Department of Mechanical and Nuclear Engineering
College of Engineering
The Pennsylvania State University
137 Reber Building
University Park, PA 16802-1412

Dr. Brian W. Sheron
Associate Director,
Engineering and Safety Systems
Office of Nuclear Reactor Regulation
US Nuclear Regulatory Commission
11555 Rockville Pike
Rockville, MD 20852

December 7, 2005

Figure 1

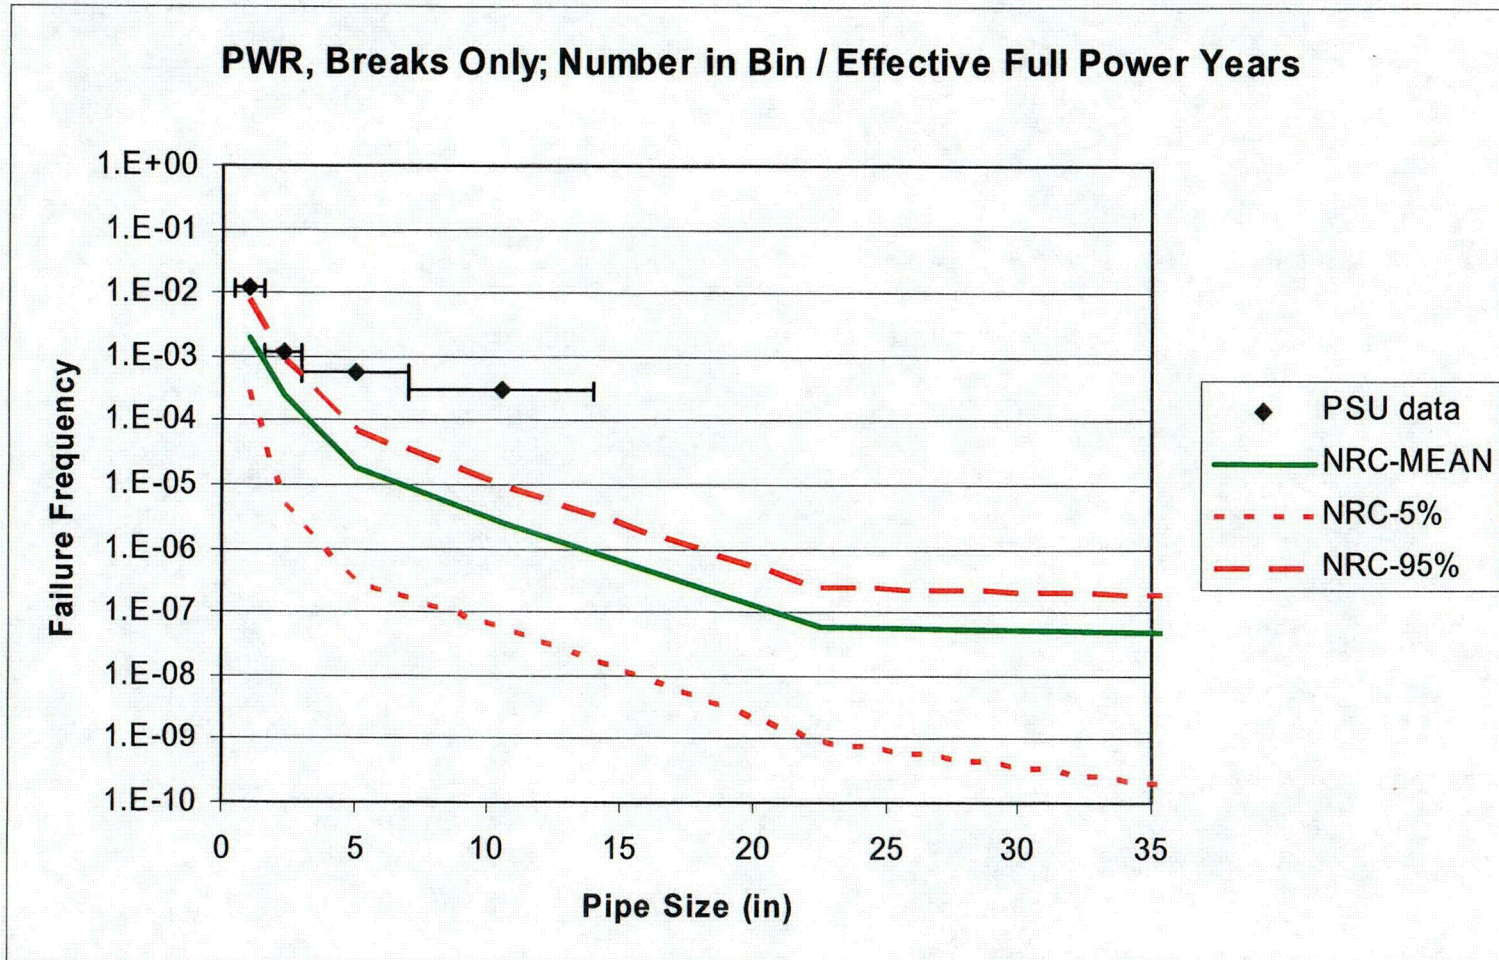
We have separated out "Breaks" from the total data base as a separate plots for both PWRs and BWRs as shown in Figures 1 and 2. As these figures indicate, there are no large breaks in the class 1 piping. However, for the smaller breaks, the data clearly lies above the estimated break frequencies estimated in the NRC solicitation study. The data is above the 95% percentile as compared to the NRC break frequency plots indicating that even smaller breaks are more frequent as compared to the estimated frequencies from the solicitation study.

Figure 3

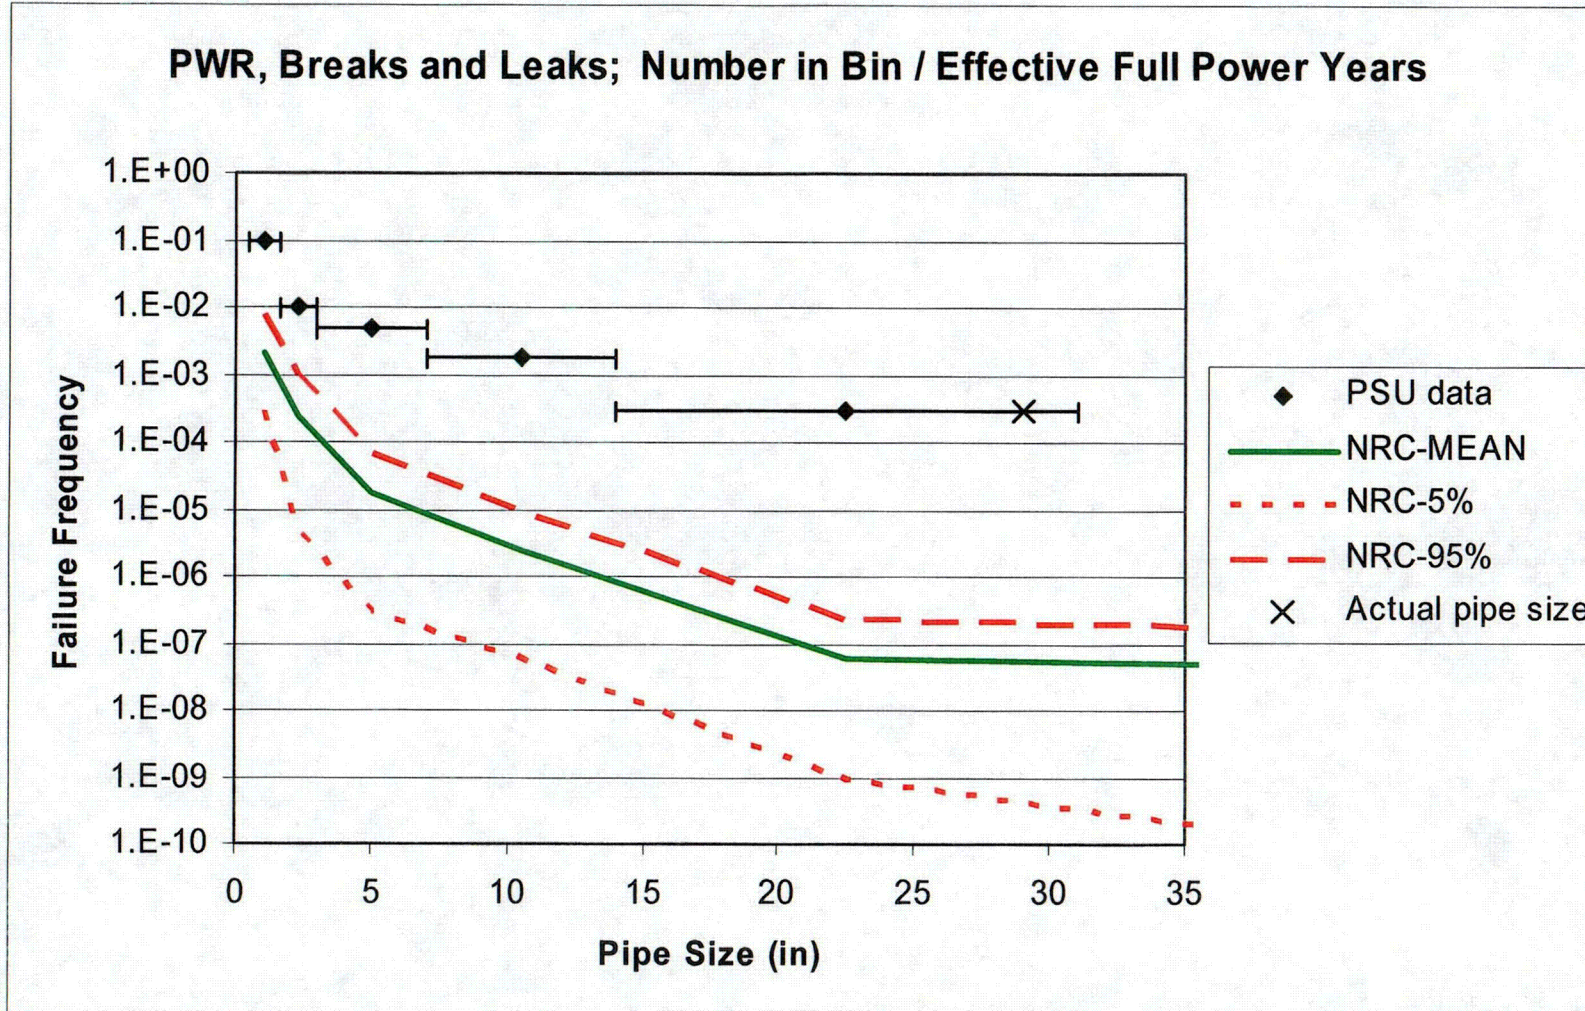
We also have combined "Breaks" and "Leaks" together on a separate plots for PWRs and BWRs as seen in Figures 3 and 4. The rationale for this is that leaks are really breaks since the pipe has failed and is leaking. We used the size of the pipe for when combining the leaks with the breaks. This may not be the best method of comparing the data to the break frequency distribution and it may appear to bias the results since there are only leaks for the larger pipes and not breaks. However, it is not clear that, given a set of conditions, a leak in a large pipe could grow to a full pipe size break. Say for example, under a safe shutdown earthquake condition. Also, this grouping could be viewed as being conservative since the original premise is that the pipes should not leak in the first place.

All the data, breaks and leaks, when combined in this form indicate that there is a significant difference between the existing data and the break spectrum failure frequencies from the NRC expert solicitation study. This indicates to me that we should not be revising 10CFR50.46 by introducing a "transitional break size" and reducing the mitigation capabilities of the plant's ECC systems and defense in depth for the larger break sizes. I believe that we need to maintain the full functional capability of the robust ECC systems that we have in the current operating plants for all possible break sizes up to and including the full double-ended break of the reactor coolant piping. The break and leak data for the class 1 piping indicates to me that we need the full functional ECC systems and their supporting systems and they should not be compromised or sacrificed by revising 10CFR50.46.
